BULLETIN

NUMBER 18

SUBJECT: Replacement Tail Brace Wire Nipples

MODELS AFFECTED: J2 Cubs, Serial Nos. 1500 to 1999 and
J3 Cubs, Serial Nos. 2000 to 2609

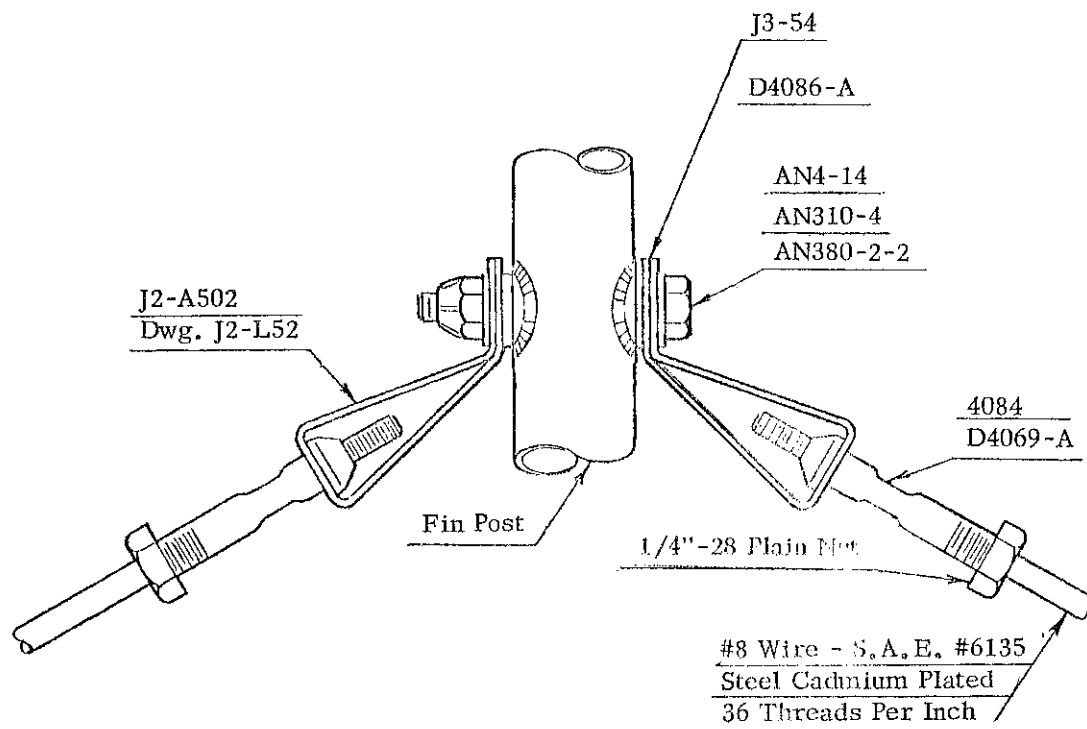
A considerable number of fatigue failures of the tail brace wires at the threaded section have been reported to this office. These failures have in most instances been caused either by ground handling or vibration.

In order to afford a greater margin of safety in the operation of our Cubs, we have designed a new type of tail brace wire nipple which we are recommending that you install at once, in order to avoid a similar failure in your installation.

This new nipple is long enough to completely cover the threaded section of the wire and has a lock nut on one end which clamps the body of the nipple to the solid section of the wire.

We would also like to call to your attention that by the installation of the new nipple the CAA will no longer require that the tail brace wire be replaced every 250 hours of service.

Note: This new type nipple can be installed on your present type wire.
